STAFF REPORT

TO: City Council
FROM: Ben Prchal, City Planner
AGENDA ITEM: Conditional Use Permit Amendment for Cedar Pet Clinic – 11051 Stillwater Blvd.
REVIEWED BY: Ben Prchal, City Planner

Re: Cedar Pet Clinic: 11051 Stillwater Boulevard
Engineering Site Plan Review

To: Ben Prchal, City of Lake Elmo Planner
From: Lucius Jonett, Wenck Landscape Architect
Date: October 12, 2018
Subject: City of Lake Elmo Landscape Plan Review
Cedar Pet Clinic Conditional Use Permit Amendment, Review #1

EXISTING CONDITIONS & REMOVALS PLAN

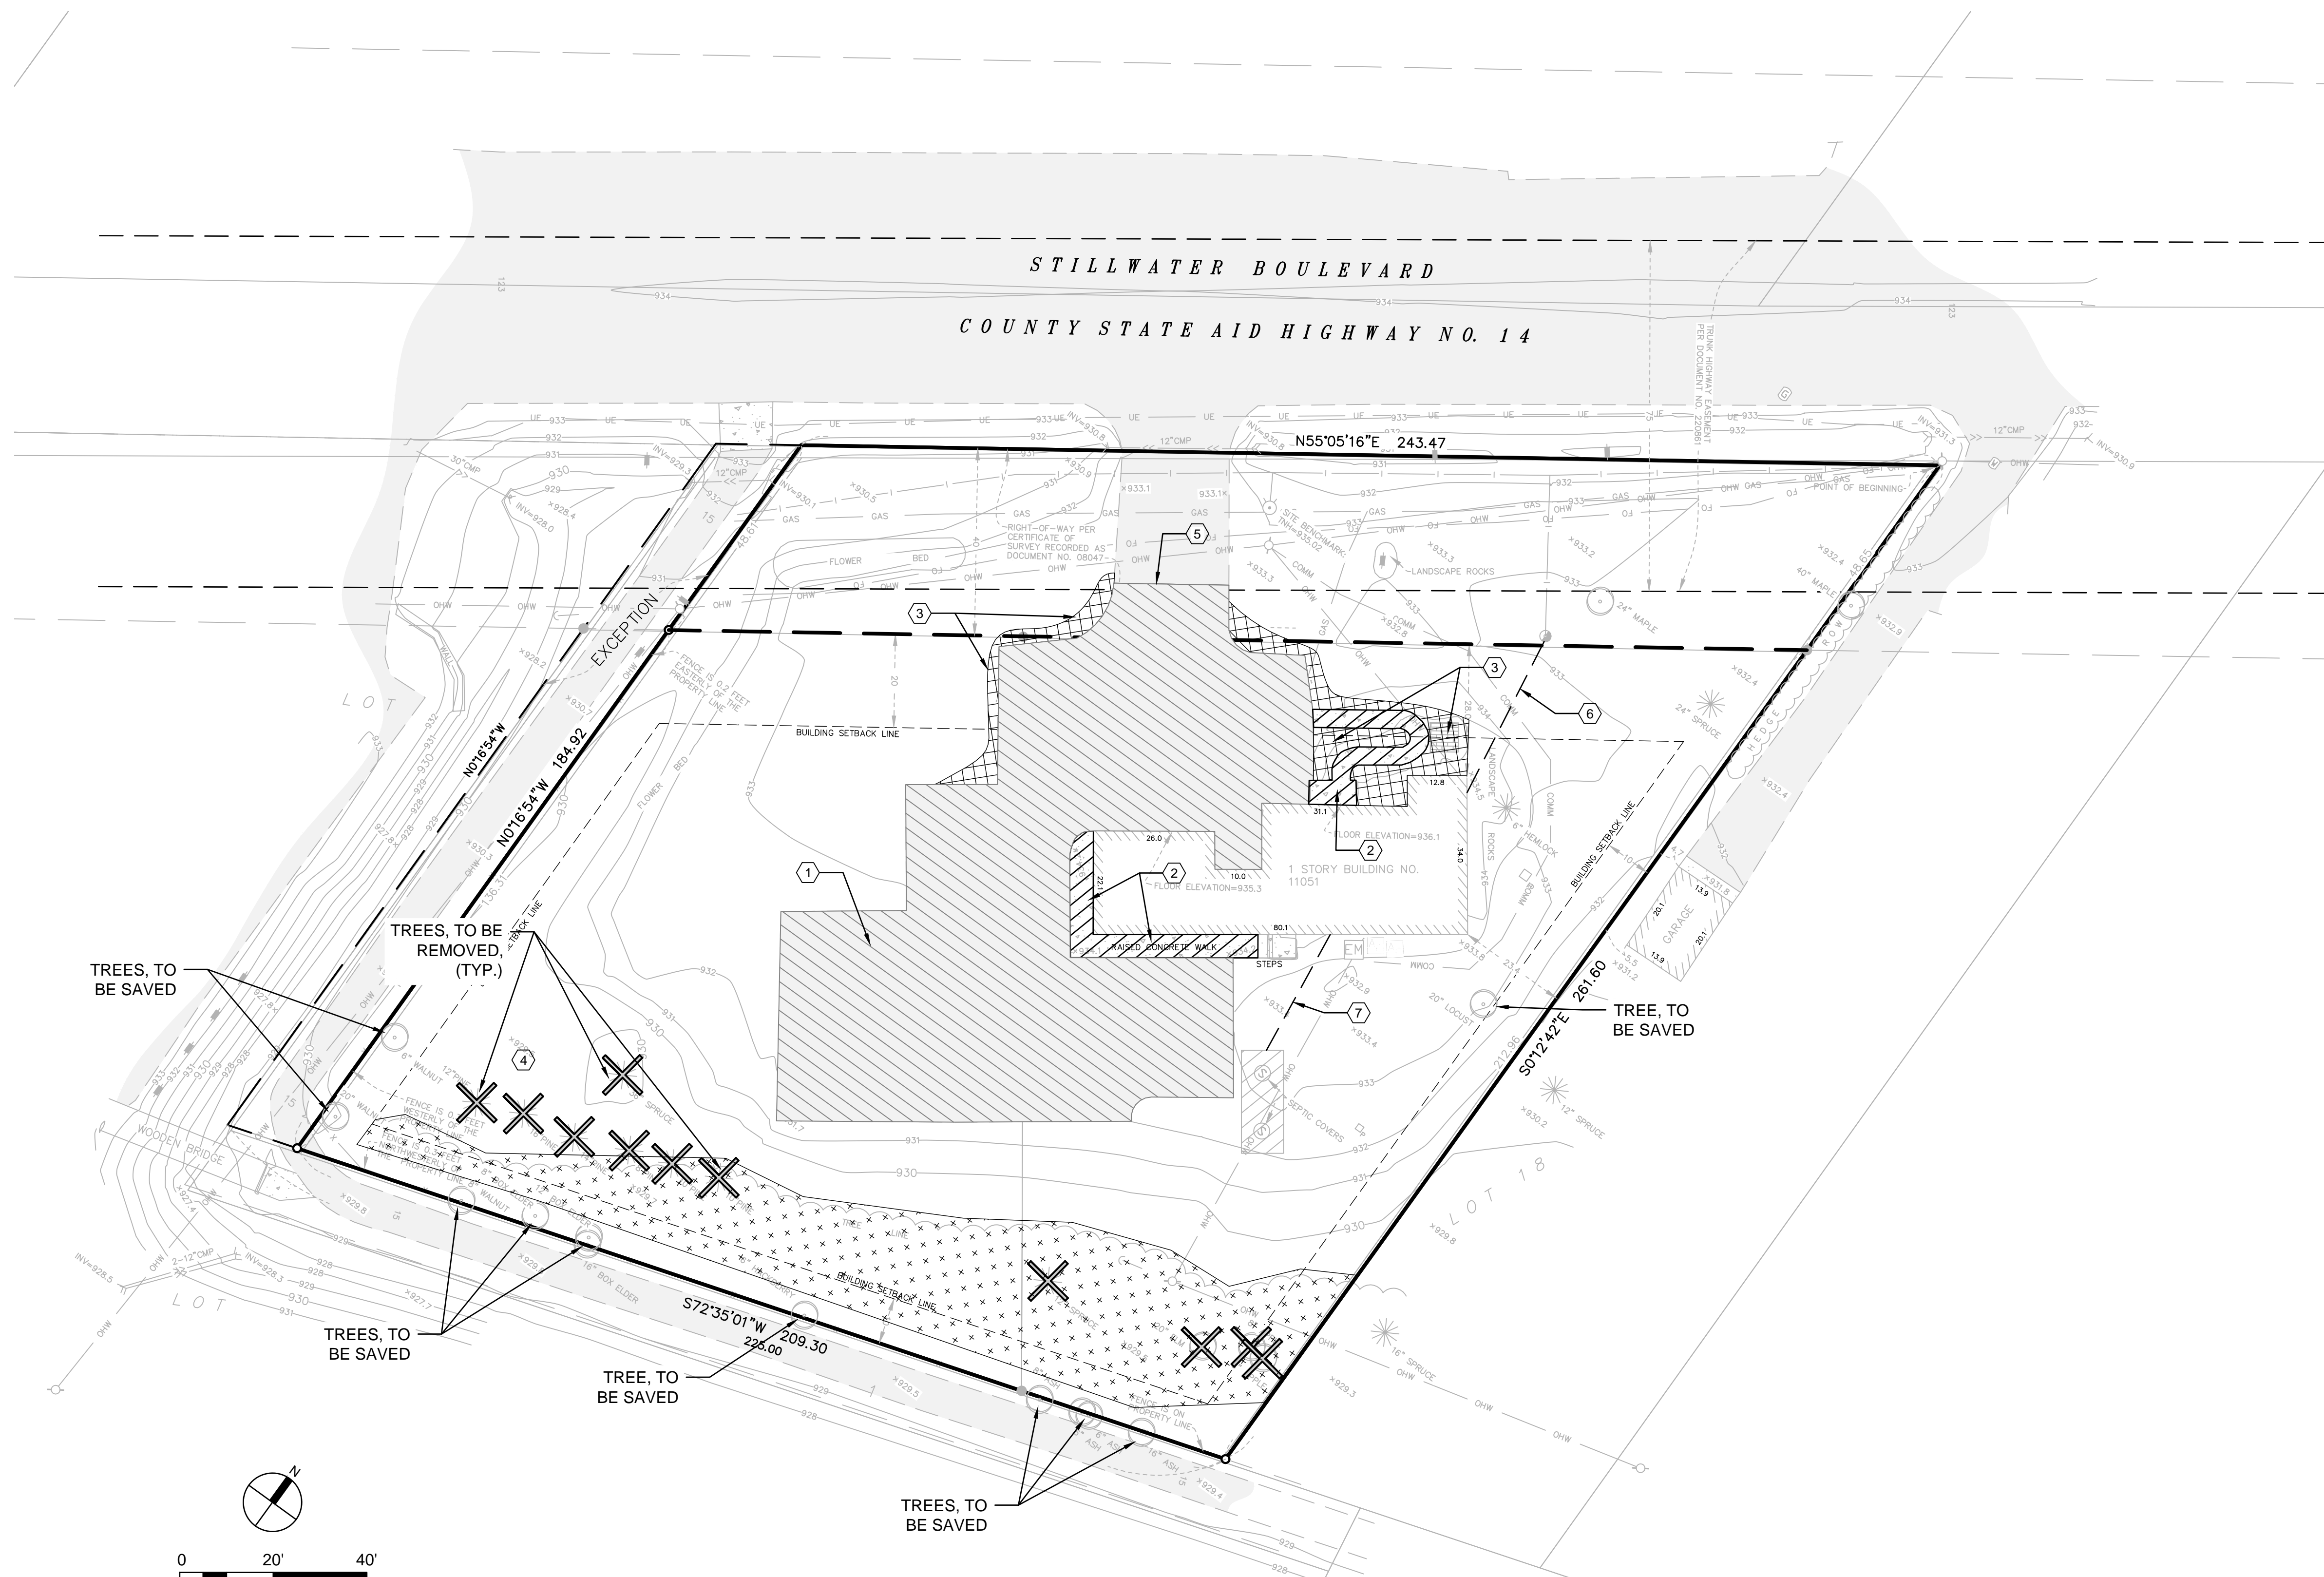
Based on review of the Existing Conditions and Removal Plan, sheet C1, the estimated tree inventory and mitigation calculations are:

2. Tree replacement calculations need to be provided confirming what was deduced from the Existing Conditions and Removals Plan, sheet C1 and to confirm the quantity and type of trees that need to be provided for mitigation of the removals in excess of the 30% removal limit for each category; hardwood, evergreen/deciduous, and common trees.

**GRADING DRAINAGE &
 EROSION CONTROL PLAN**

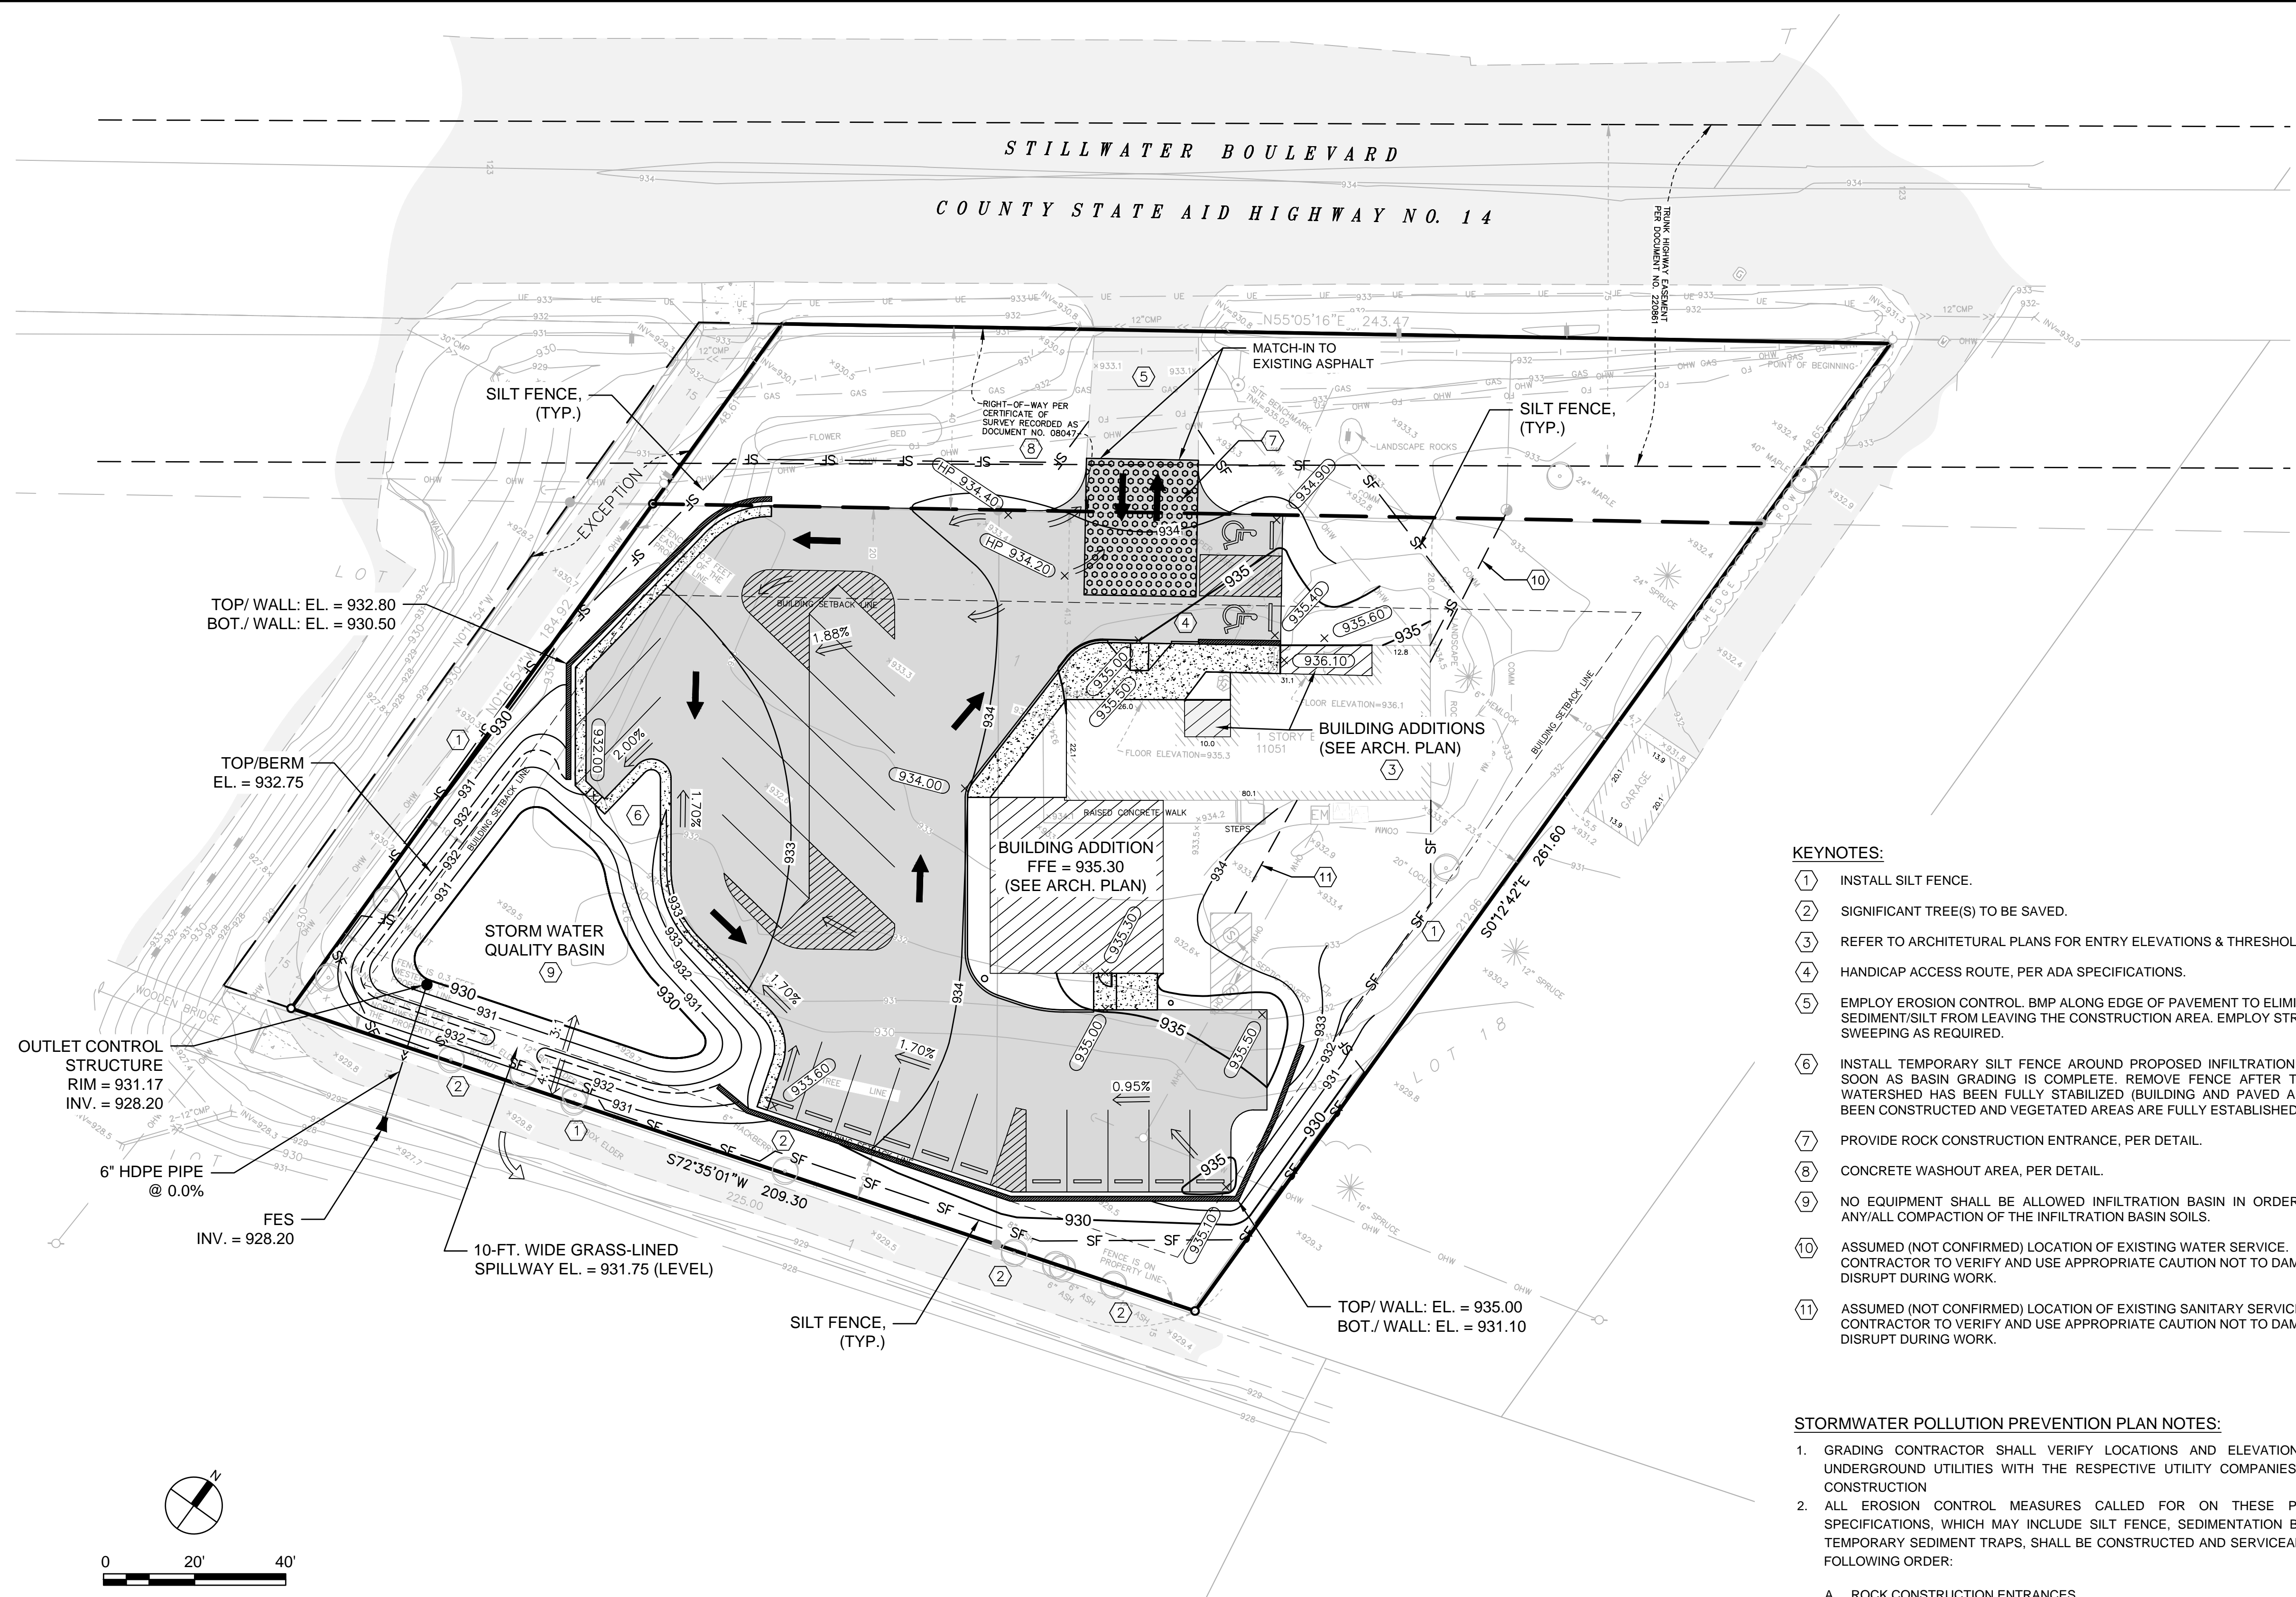
6. A storm water infiltration basin is proposed in the southwest corner of the property to mitigate the new impervious surfaces and to comply with VBWD rules. Soil borings must be taken to verify that the in-place soils are suitable for infiltration. Soils must be type A or B to allow for infiltration practices.
